UNITED NUCLEAR CORPORATION
FUELS DIVISION

Subject: Amendment to SNM 777

Attached are six (6) copies of a proposed revision to SNM 777. These revised pages describe new equipment installed to augment our processing capabilities.

SUBJECT: PROCESSING - FACILITIES AND EQUIPMENT

PLAN

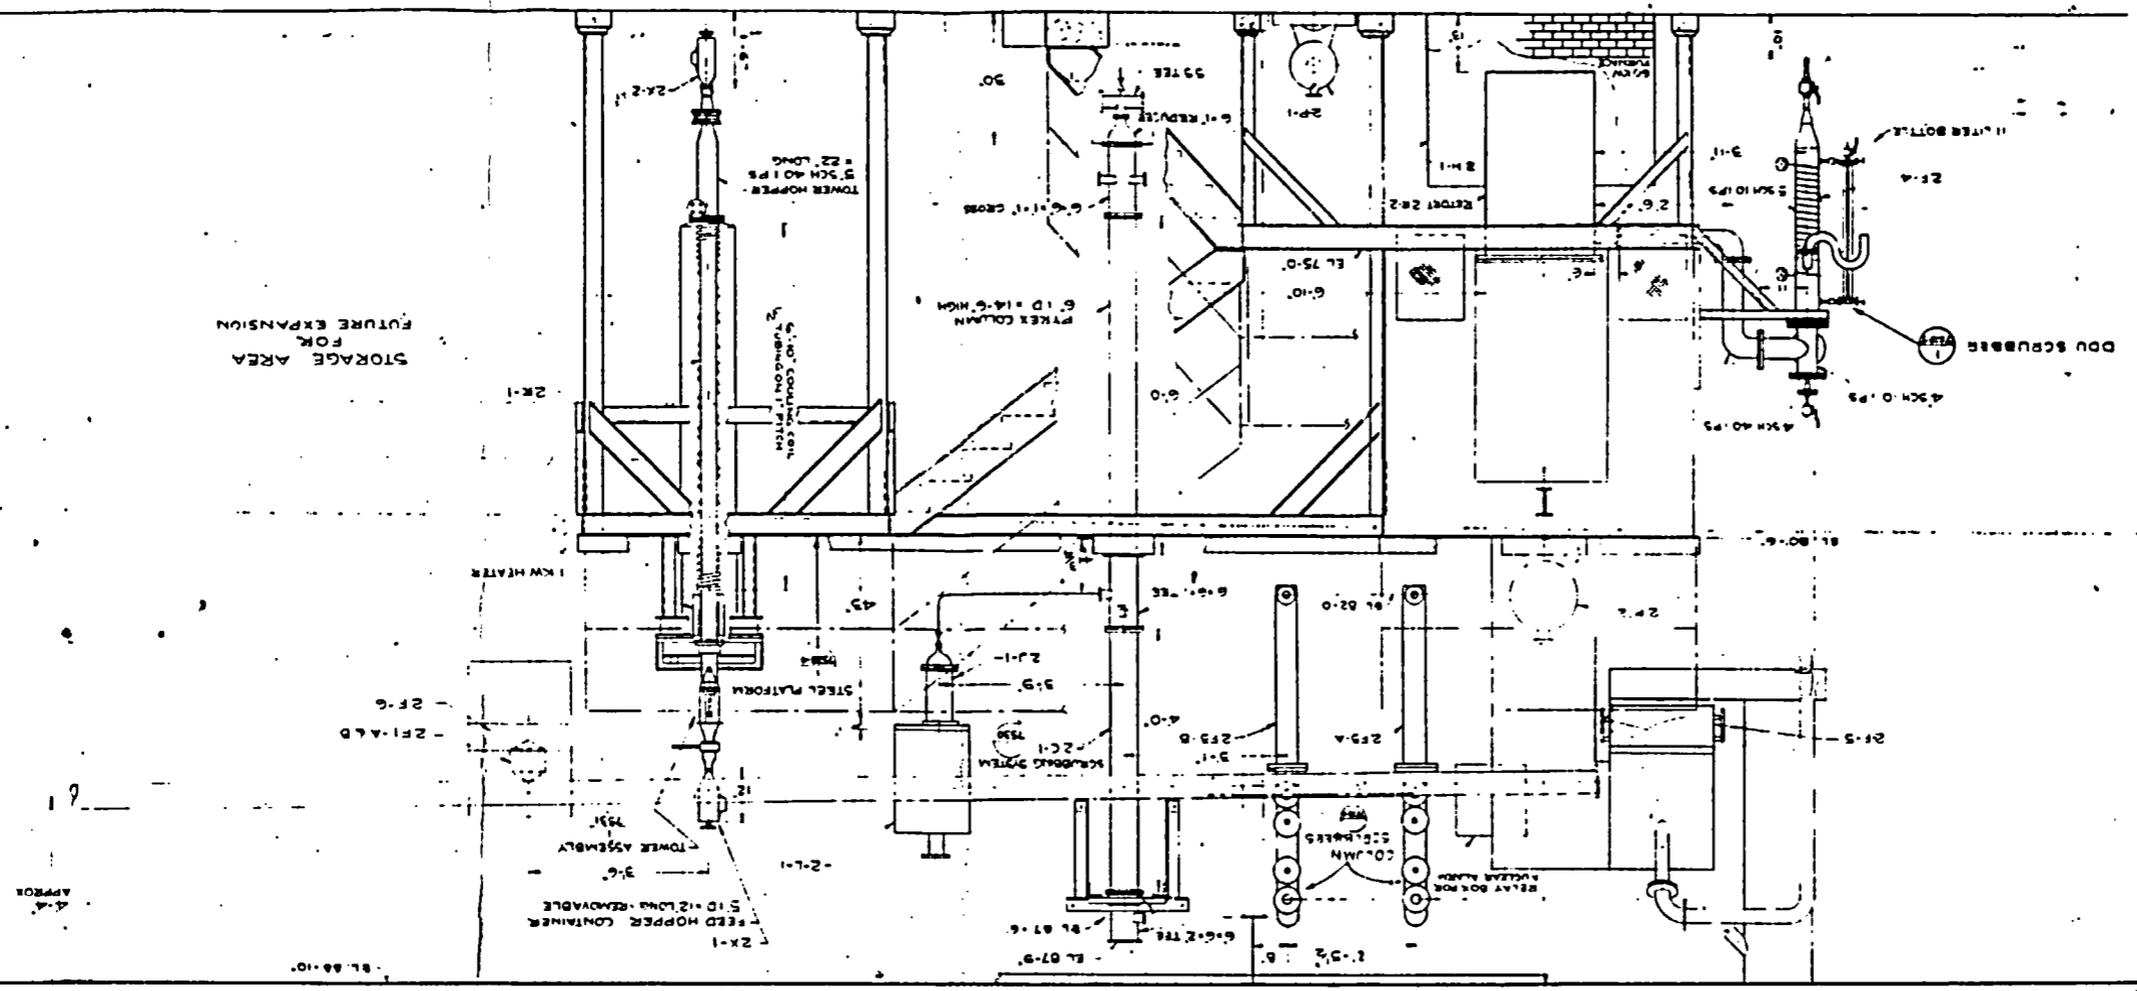
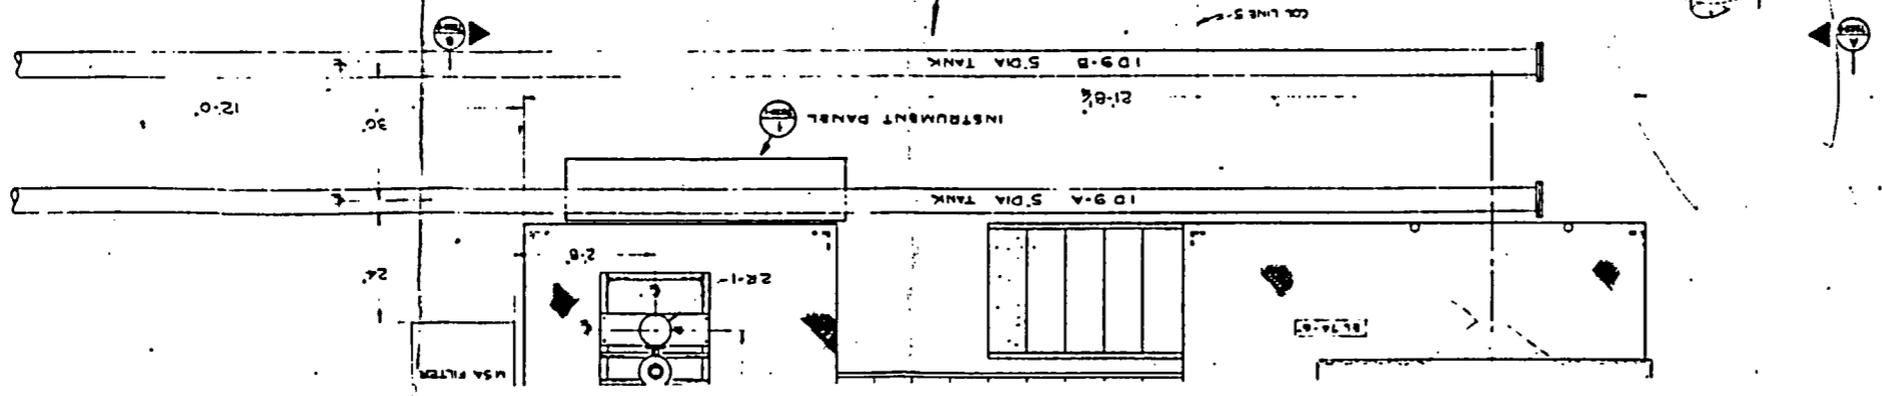
The amount of U_{235} will always be less than 550 gms, determined from shippers estimate and visual inspection. As shown by Drawing E 7528 Rev. 2 an isolation distance of approximately 4 feet is maintained around this retort 2 R2.

Interaction between this column (2C1) and other units (refer to layout Dwg. E-7528 Rev. 2) are as follows:

FIG. 1 REACTIVITY OF UO₂F₂ SOLUTION IN 6-INCH DIAMETER BORO-SILICATE GLASS PIPE

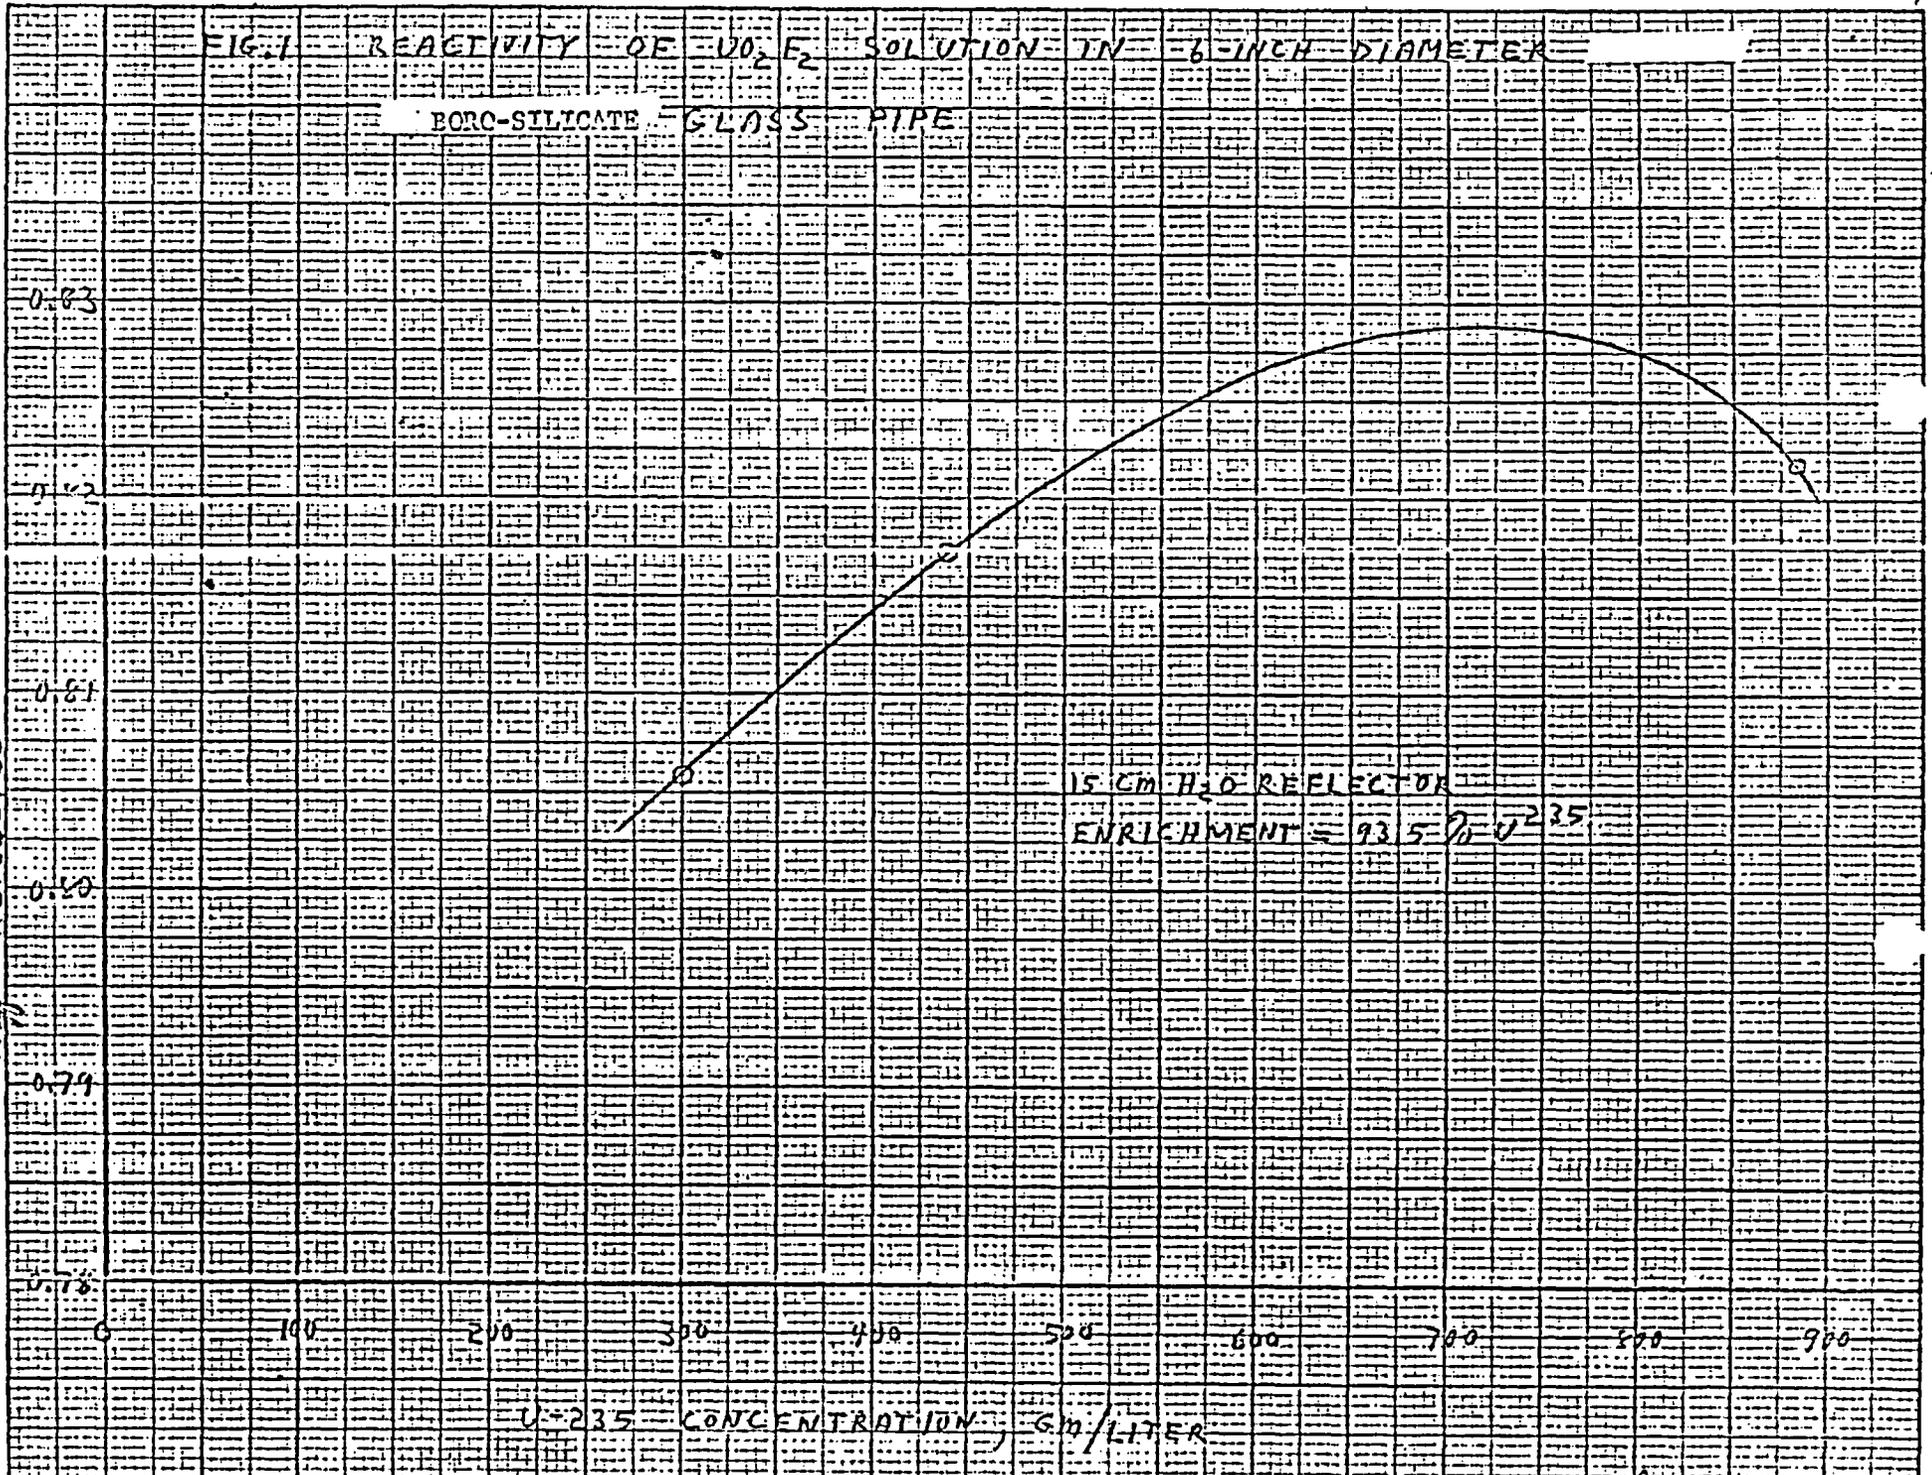
Problems 1, 2, and 3 yield k_{eff} as a function of solution concentration for reflected conditions. These data are plotted in Figure 1. The maximum value of k_{eff} is 0.83. Even allowing for a 3% non-conservative calculational bias, which is not warranted by the results of the checks against UO_2F_2 solution critical experiments, the maximum k_{eff} would be 0.855. This is sufficiently below unity to assure a sub-critical system regardless of solution concentration or presence of a water reflector.

A k_{eff} value of 0.836 was predicted by DTF. This is greater than the maximum value of 0.829 given by Figure 1 for the boro-silicate glass pipe. It is, therefore, concluded that the proposed boro-silicate glass pipe is at least as safe for uranium solutions as a 6-inch diameter cylinder wrapped with cadmium. The results of this comparison are also consistent with the relative effectiveness data given in Reference 9.
